**August 27, 2013
Medway Planning and Economic Development Board
155 Village Street
Medway, MA 02053**

PUBLIC HEARING CONTINUATION - Medway Commons Site Plan Modification – Starbucks Coffee House;

PROPOSED CANOPY ELEVATIONS CF12.0

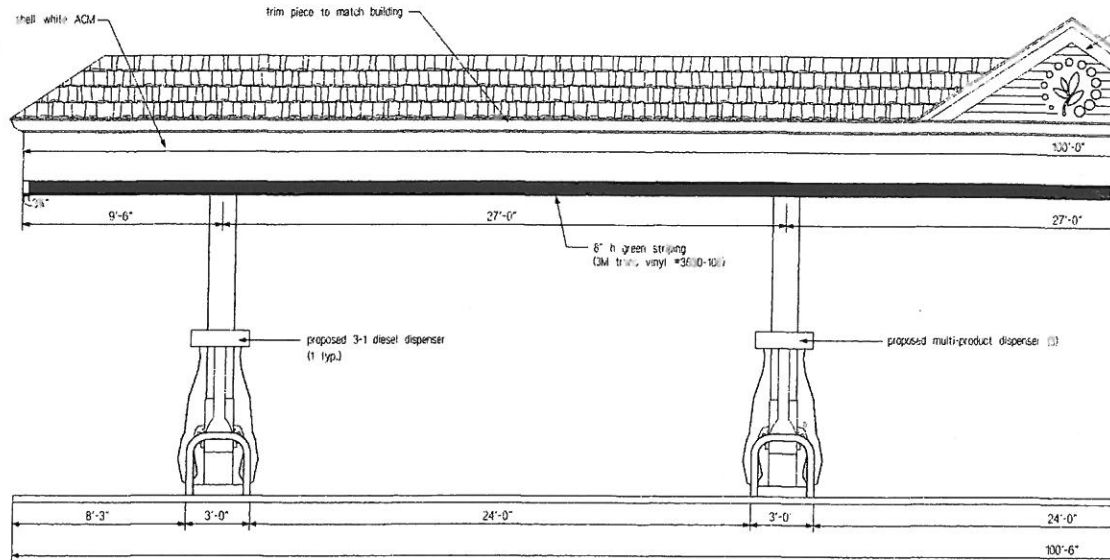
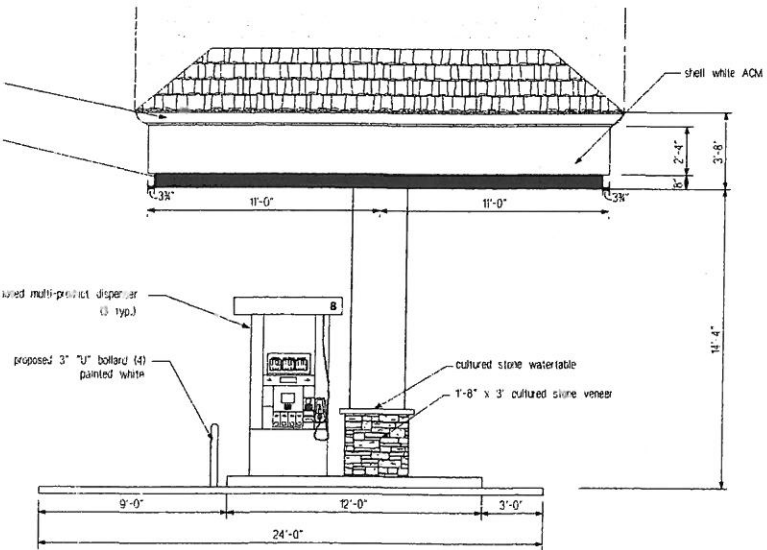
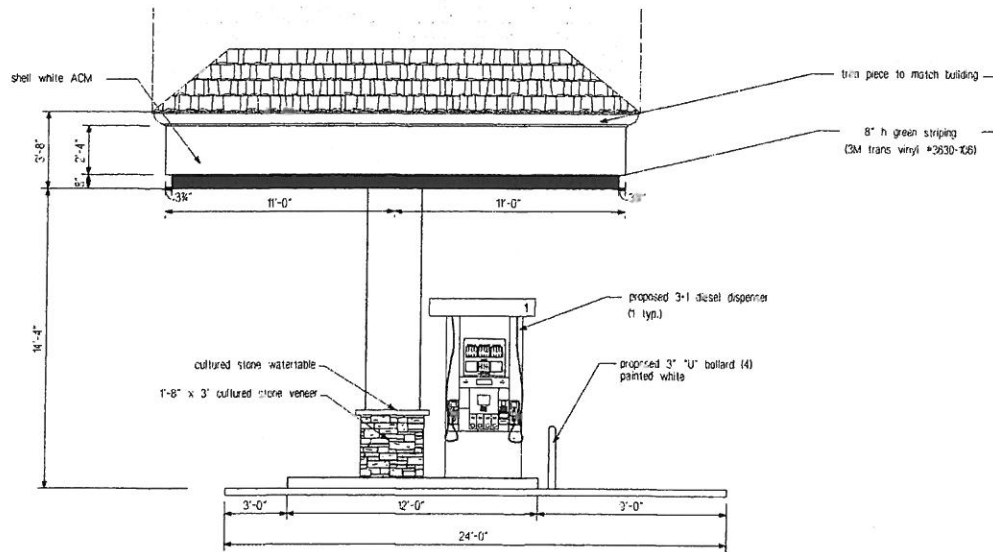
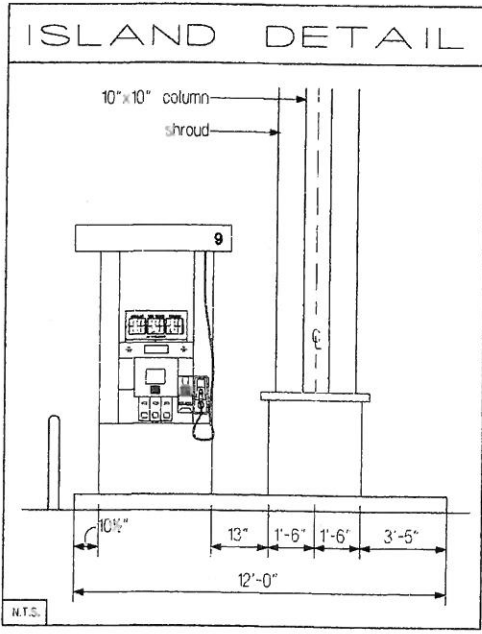
The Chairman indicated that the renderings do not show the second means of egress.

ALSO . . . the PEDB is VERY concerned about the overall size and length and scale of the large overhead canopy above the 4 gas pumps. There was a suggestion that the canopy be divided into two sections with some space in the middle. The applicant represented that such an arrangement would not comply with the fire suppression system requirements. Would you please comment on that and provide suitable documentation?

1. The first major concern is the mass of the canopy over the gas pumps. The bylaw is very clear about the maximum size of the canopy area (Section V-K 1 (l) (1) b) The DRC suggestion to add large trees (which the applicant has agreed to) may address the visual impact of the canopy but it does not address the size issue. The second suggestion by DRC to create an opening in the canopy would likely address the maximum area issue, but the applicant has explained that this is not feasible. However, I understand that the applicant has agreed to redesign the canopy in order to comply with the bylaw.

The applicant communicated that they redesigned the canopy in order to comply with the zoning bylaw. It has been reduced to 2200 square feet. Attorney Paulousky also presented a pamphlet from the state Fire Marshall's office regarding blasting. It was also conveyed that the applicant is 90% done addressing the comment letter from Tetra Tech. They are working on updating the renderings. Five views of those were shown as a power point presentation. These were photo simulation renderings.

DEFINITIVE OSRD LAYOUT PLAN
"CHARLES RIVER VILLAGE"
OSRD DEFINITIVE PLAN
IN
MEDWAY, MASSACHUSETTS

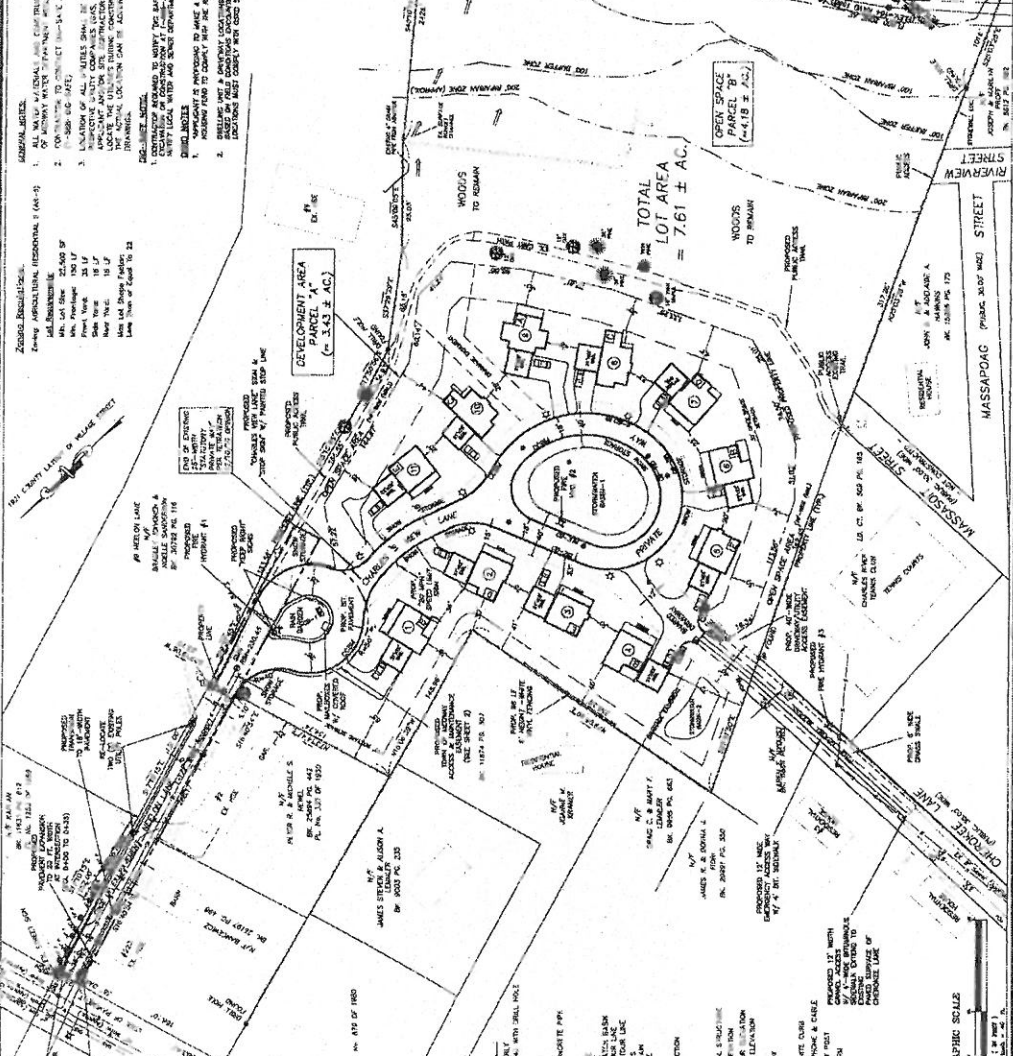
As a follow up to our telephone conversation, I was not happy with the response from the building commissioner that the builder had the right to move houses slightly if he ran into ledge or rocks. The first house was moved seven feet from the original plans closer to my property line. Seven feet is not a slight move and I do not think he ran into any rocks or ledge to warrant any move. I do not think the planning board had intended the houses to be any closer than the approved plans.

I would like the planning board to weigh in on this and make a decision if the builder had the right to move the house 7 feet closer than the plans allowed. I would like a cease and desist on the building on that first house until a decision has been made and I would like to be assured that the next three houses behind my property be the correct distance from my property line according to the plans.

You have stated that you believe the 23' distance from your property line to the back of the first CRV house does not comply with the CRV plan which shows a 30' distance. Attached is Sheet #4 from the endorsed Charles River Village Definitive Plan. It does show 30' as you understood it to be. However, please see OSRD note #2 in the upper right hand corner of the sheet which indicates that the location of the houses and driveways as shown on the plan are approximate and subject to change depending on field conditions.

The Board noted that the plan shows 30 ft. but there is a note on the plan that the dwelling unit locations are approximate.

The Board noted that this is in compliance.
